RE: *Permit No. PI2019-0013 Parkside Unit 1 (Review 5)*

Please find listed below our responses to your comments in regard to the Parkside Unit 1 project.

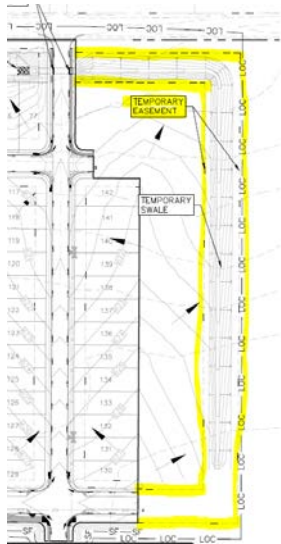
- 75. Specify at what phase of Parkside will the temporary Channel A1 will become permanent.
  - Temporary Channel A1 will be removed in the development of Parkside Phase 2 and replaced with Extended Detention Basin A2.
- 76. Please verify if EX A2 flows for the 2-year and 10-year are the same.

- *The 2-year storm event information has been corrected and updated.*

Concentration	Description	Drainage Area	Area	T <sub>c</sub>	Curve Number	Q <sub>2</sub> (cfs)	Q <sub>10</sub> (cfs)	Q <sub>25</sub>
EX A1	Longest Time of Concentration Analysis	EX A1	25.12	49.73	78.00	35.56	54.39	53
EX A2	Longest Time of Concentration Analysis	EX A2	10.47	35.30	78.00	6.62	17.91	26
EX A3	Drainage Sub-Area A14 Comparison	EX A3	68.84	45.35	78.00	101.56	91.62	15
EX A4	Longest Time of Concentration Analysis	EX A4	50.18	86.98	78.00	48.80	133.80	72

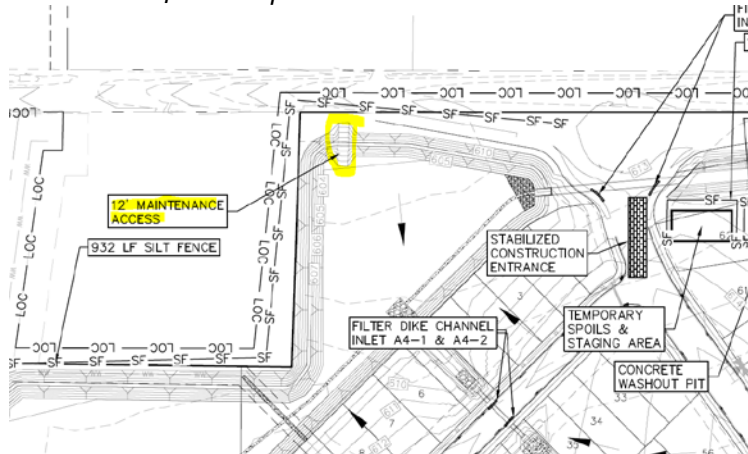
79. Per the New Braunfels Drainage and Erosion Control Design Manual Sec. 10.1(O), maintenance access to detention pond must be provided and shall be a minimum of 12 feet wide and have no greater than a 6:1 slope. Please provide a 12-foot maintenance access path to the ramp on the west side of the pond, since it seem it leads to the 4-foot top of the berm as shown on sheet C5.09.

- The maintenance access for Extended Detention Basin A1 has been relocated to provide better access to the ramp. Its new location is shown below and can be accessed from Pieper R.O.W.*

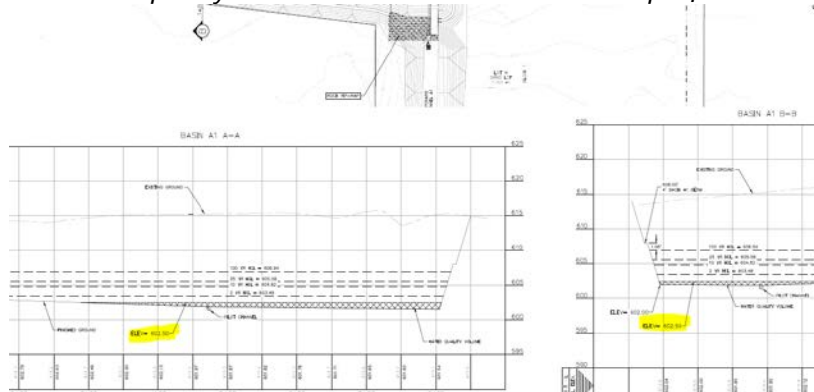
80. In accordance with TCEQ RG-348, verify the detention pond design accounts for the required water quality volume. These volumes must be separate, and the detention volume must be provided on top of the water quality volume. Please show the water quality volume elevation in the pond profiles on Sheet C5.09.

- The water quality elevation has been added to the profile on sheet C5.09.*

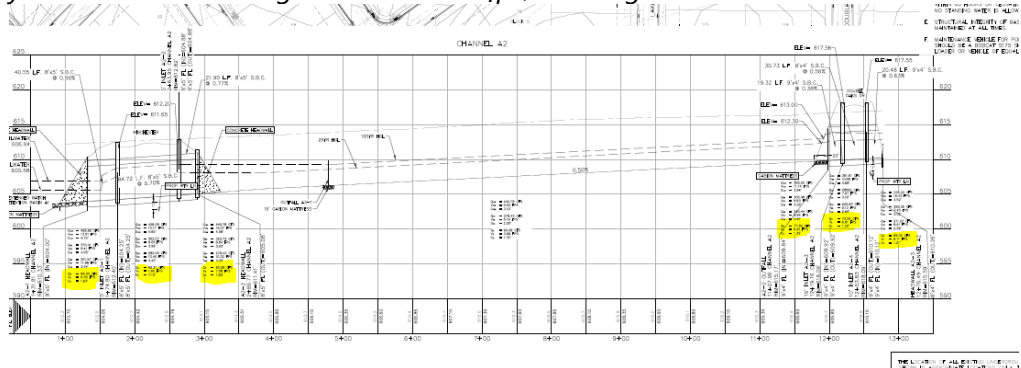
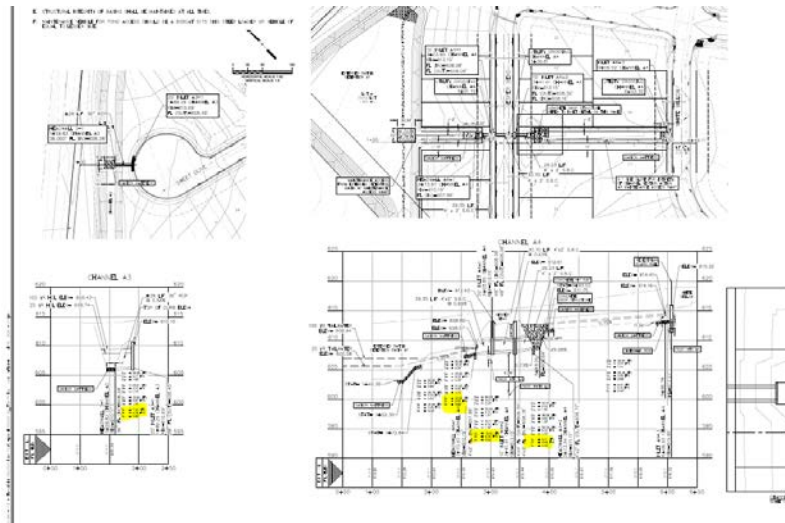
81. Per the New Braunfels Drainage and Erosion Control Design Manual Sec. 9.1(G), culverts shall have a minimum storm velocity of 2.5 fps in the 2-year storm. Provide 2-year velocity for all culverts.

- The 2 year storm event information has been added to the profiles on sheets C5.05 and C5.07 of the construction drawings. The calculations can be found on pages 424 through 426 of the drainage report. All velocities during the 2 year storm event are greater than 2.5 fps, meeting the DECDM criteria.*
